November 8, 1982

United States Nuclear Regulatory Commission
Washington, D. C. 20555

Subject: Revised Response to 440 Series RAIs; (Reactor Systems Branch)

Charging SI pump

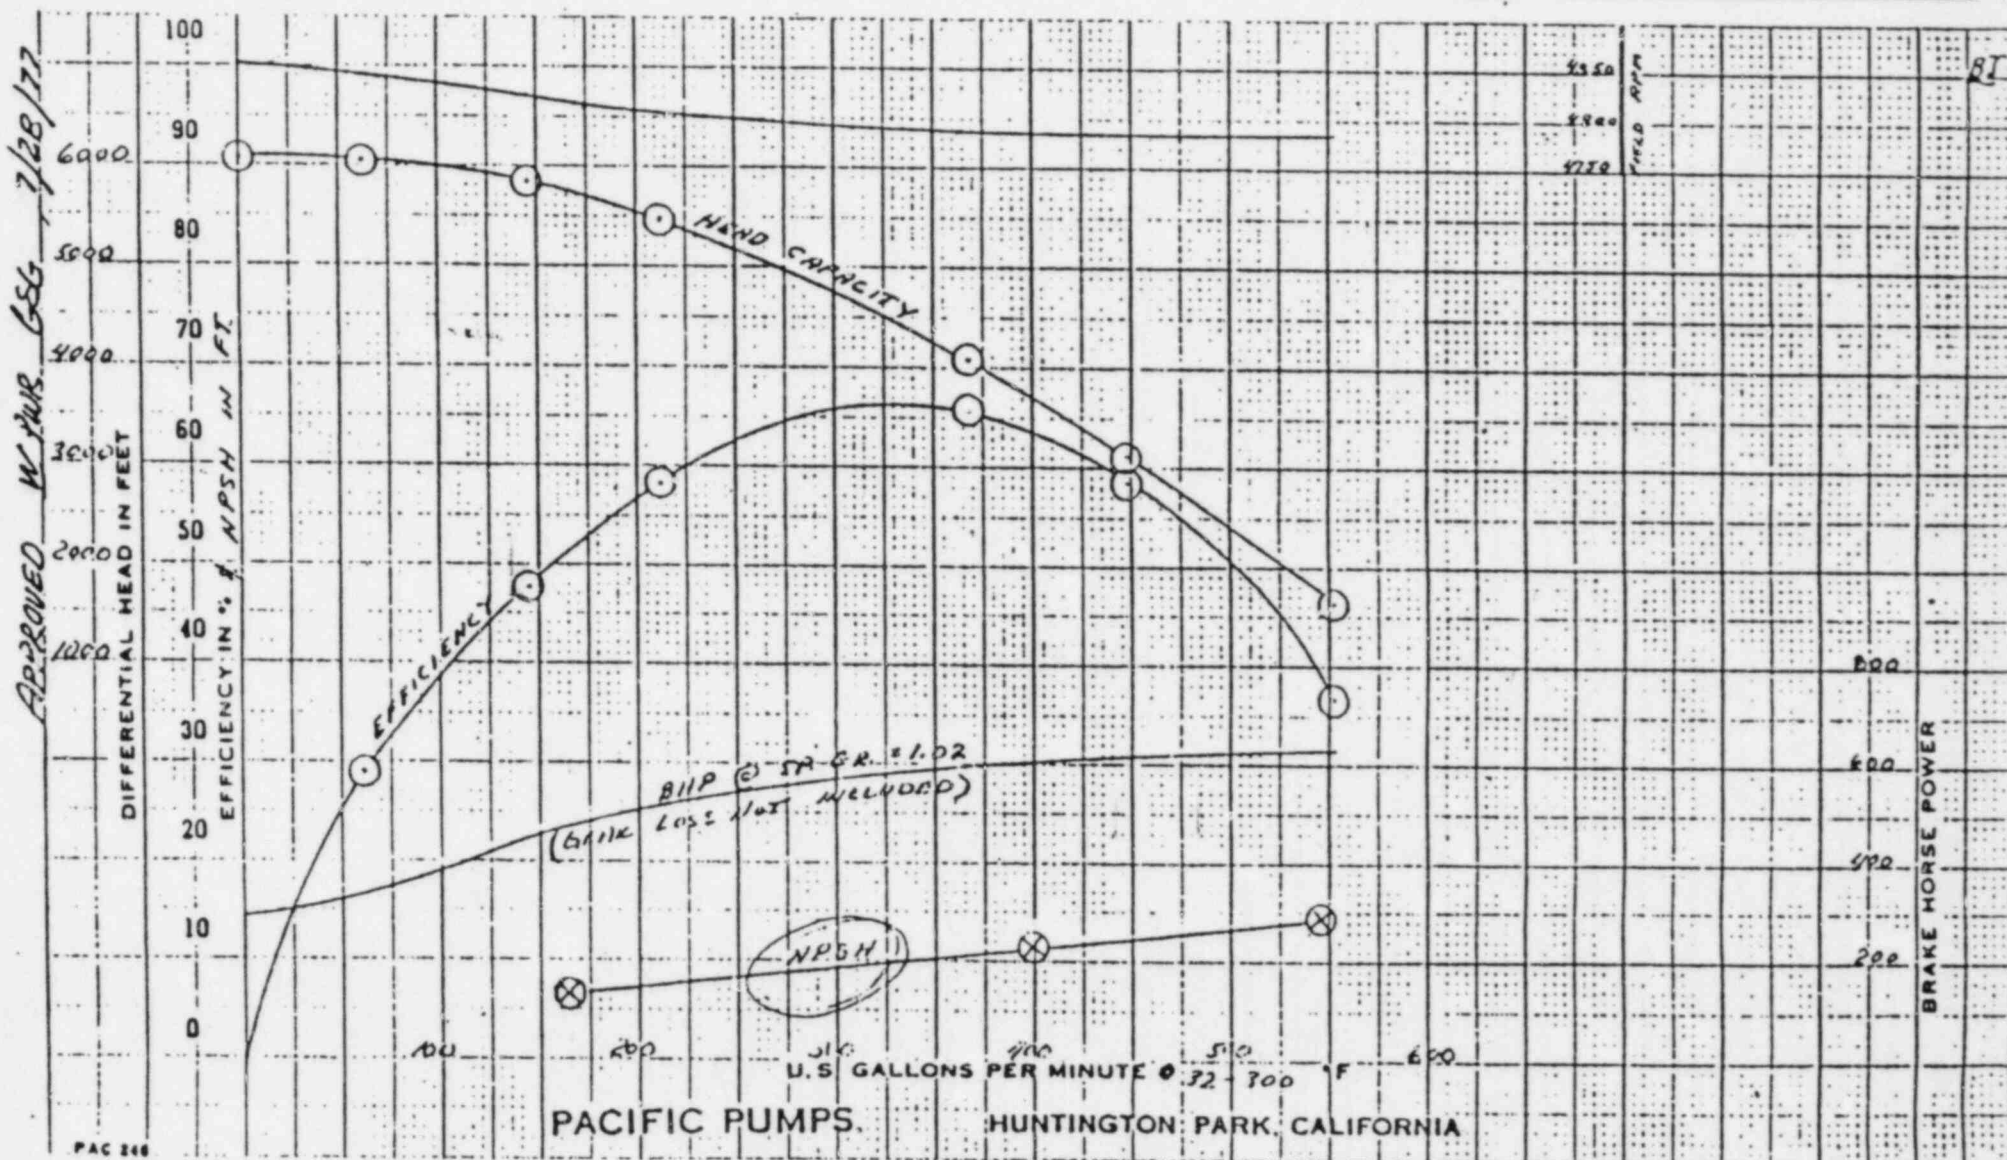
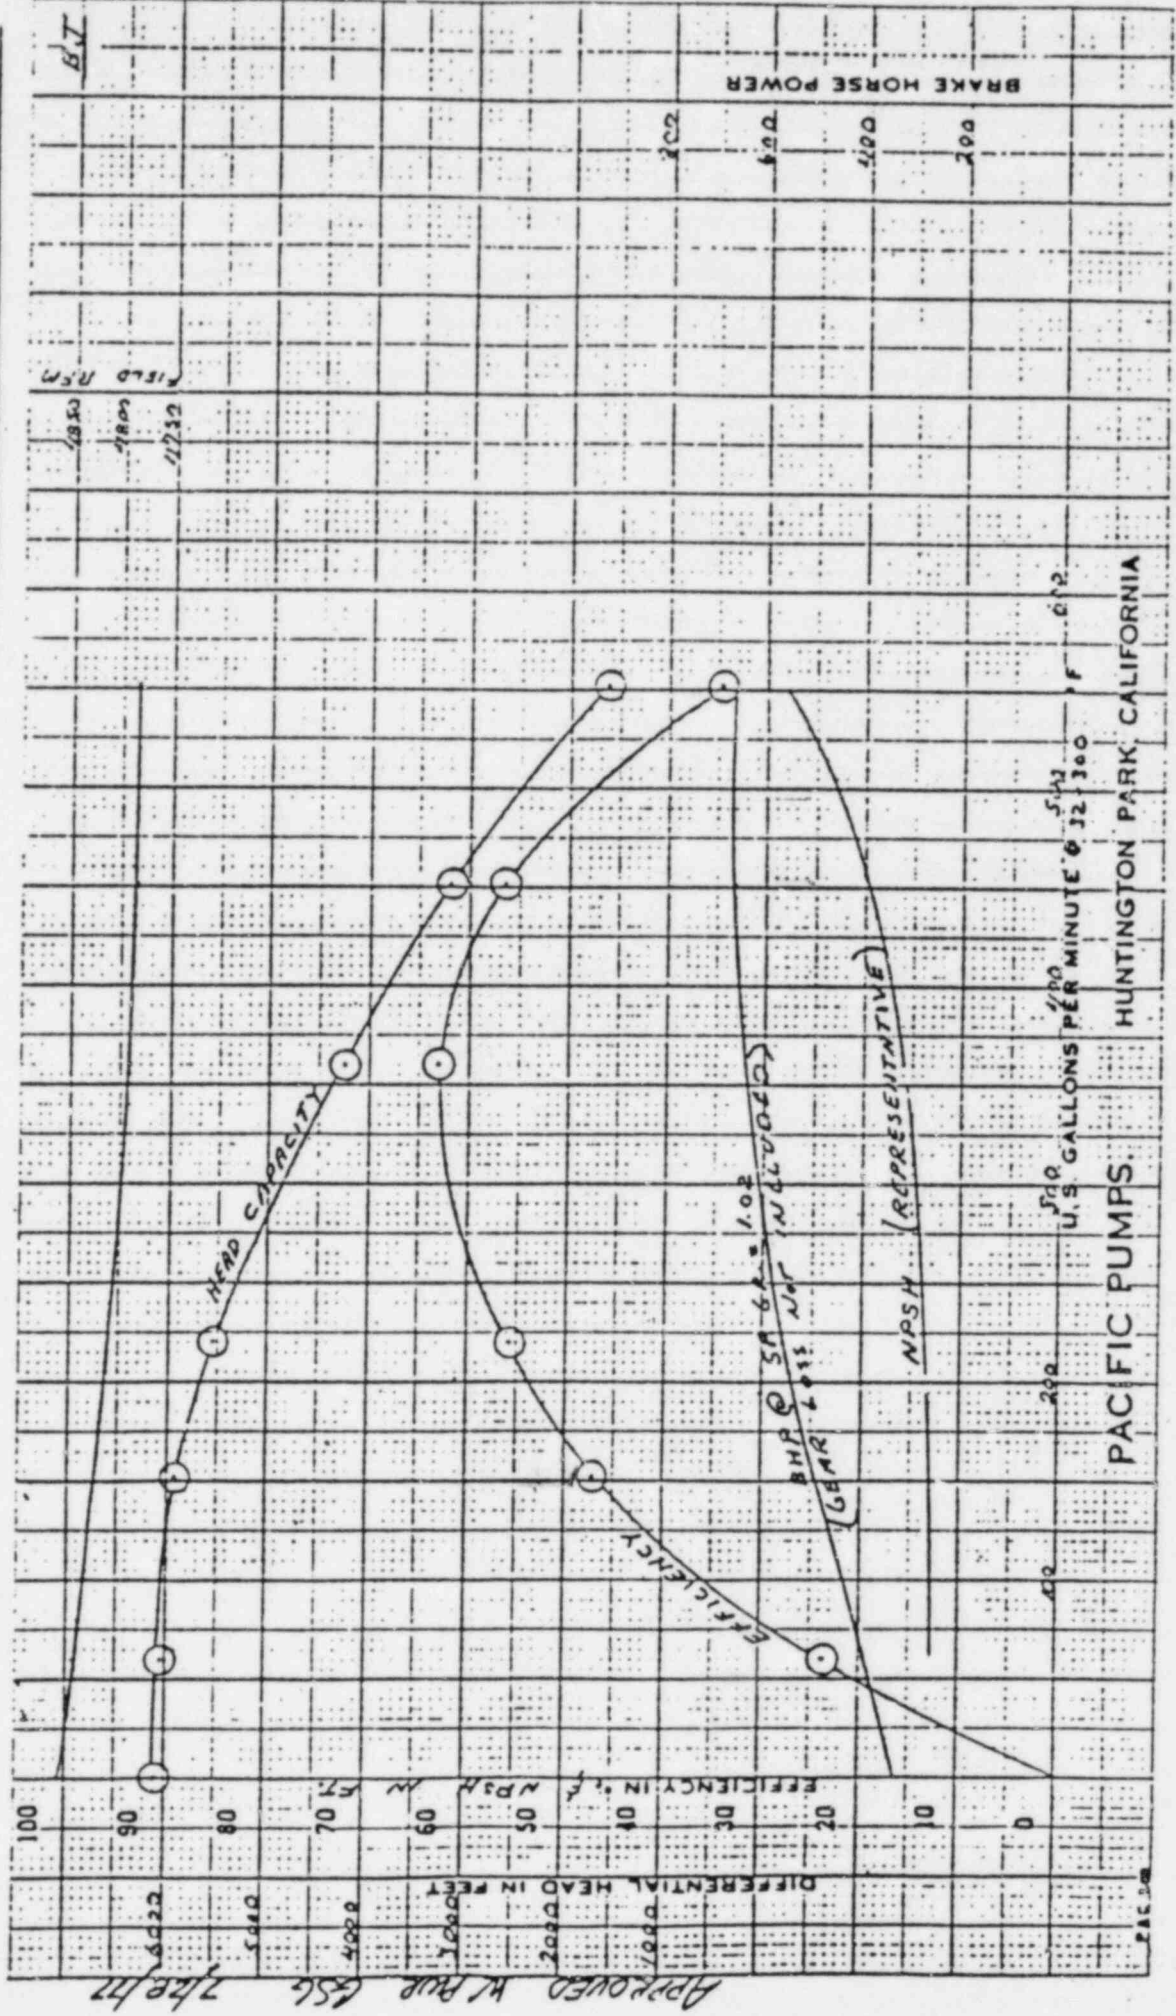
Provide a discussion of NPSH requirements for all ECCS pumps. Include in this discussion NPSH as required by pump warranty, estimated variability between pumps, and testing inaccuracies. Also provide the assumptions and calculations used to establish available NPSH.

RESPONSE: A discussion of the calculational method used to determine the NPSH for the ECCS pumps is given in Seabrook FSAR Section 6.3.2.2. For RHR pumps, see also Section 5.4.7. The required and available NPSH values are given in Table 6.3-1. Pump curves for RHR, HHSI/CH, SI pumps are attached.

ECCS pump specifications include a specified maximum required NPSH which the pump is required to meet. Pump vendors have verified that the required NPSH for the pumps was less than the maximum required NPSH through testing in accordance with the criteria established by the Hydraulic Institute Standards. Further, from the pump head/flow and NPSH required characteristic curves that are derived from the testing, Westinghouse subsequently confirmed that adequate NPSH is available based on the actual system piping layouts, and conservatively calculated maximum pump runout verified by preoperational testing.
